ADDENDUM TO SPECIFICATION 5804S, ISSUE 8, DATED MARCH,
1964 COVERING MODIFICATION KITS 154785 AND 163146

INSTRUCTIONS FOR INSTALLING THE 154785 OR 163146 MODIFICATION KIT ON A MODEL 28 TYPING UNIT OR SEQUENCE SELECTOR UNIT TO ADD A UNIVERSAL CONTACT

FIGURE 1

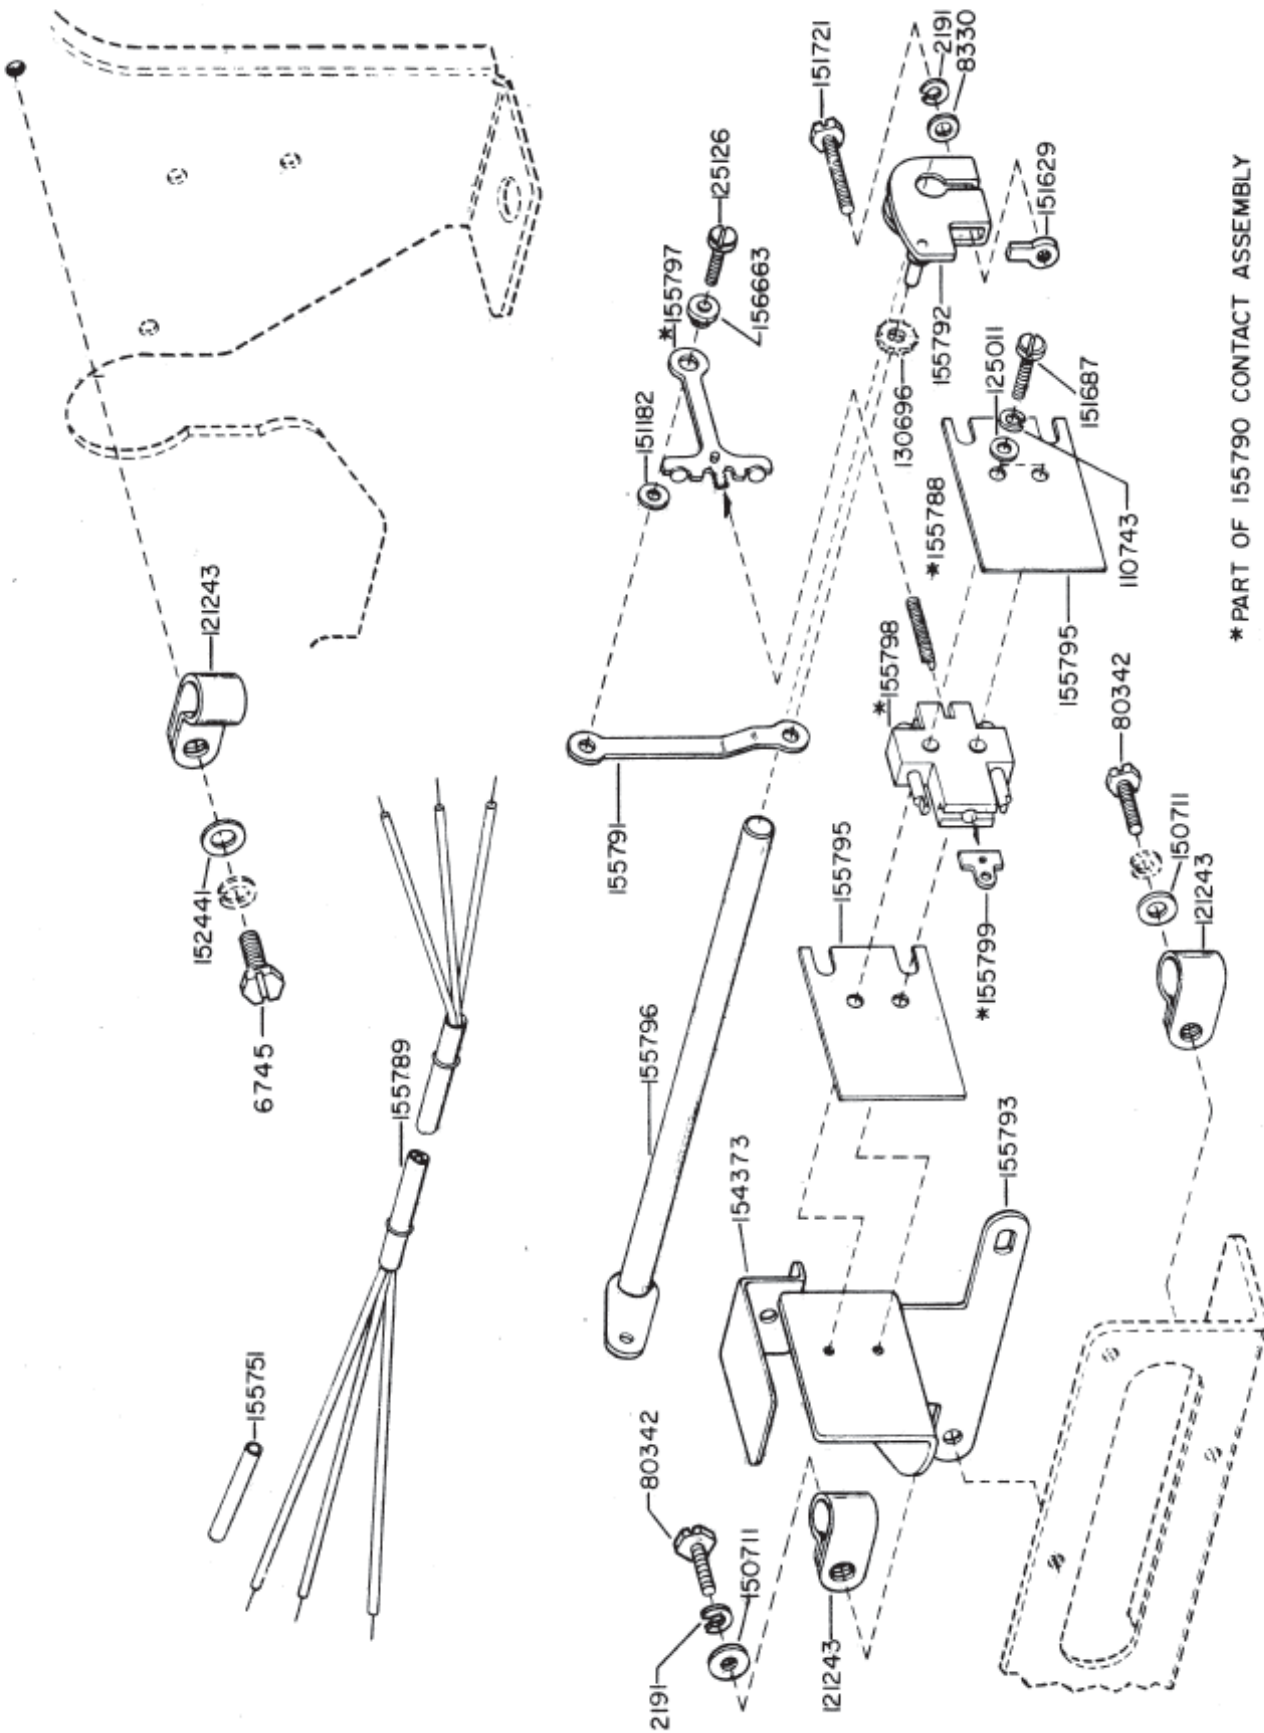
1. Make the following changes in Specification 5804S:
 - a. On Page 2, Paragraph 1.d. add 2-90790 Washer, Flat.
 - b. On Page 6, Paragraph 2.b.(7)(a)2. Add the following to the paragraph: and insert one 90790 Lock Washer between the 163158 Bracket and the left stunt box bracket.
 - c. On Page 6, Paragraph 2.b.(8) add the following new sentence: For LP Units only: insert a 90790 Flat Washer between the 163158 Bracket and the left stunt box bracket.
 - d. On Figure 1, Bracket 163158, in the holes marked (B) and for parts 7002, 2191, and 151346 add the following: For LP Units only: use 90790 Flat Washer. (See Paragraphs 2.b.(7)(a)2. and 2.b.(8).
